Question from Kyle Kunka Sea West Enterprises, Inc. on Thursday, Mar 20, 2025 at 08:56 AM PDT

**ROTATING ENCLOSURE EMERGENCY
SHUTDOWN CONTROL DIAGRAM**

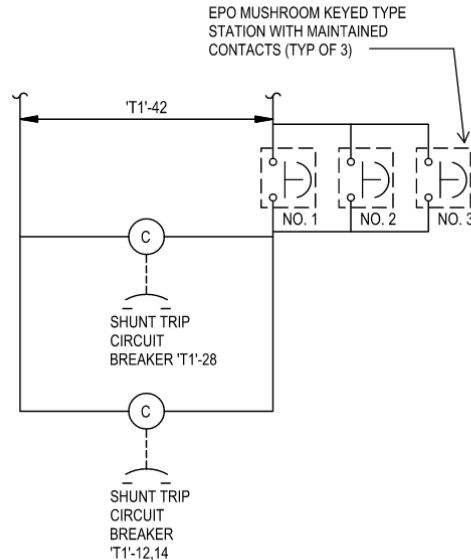
3. Is weed abatement required for the area of work? **No**
4. Are any of the landscape plants to be salvaged? **No**
5. Sheet EP101, Keynote12 states to refer to EP701 detail #2. however, on sheet EP701, there is no detail 2. Please clarify the correct detail for this note.

Below is the detail. It is referenced as detail #1, and should be #2.
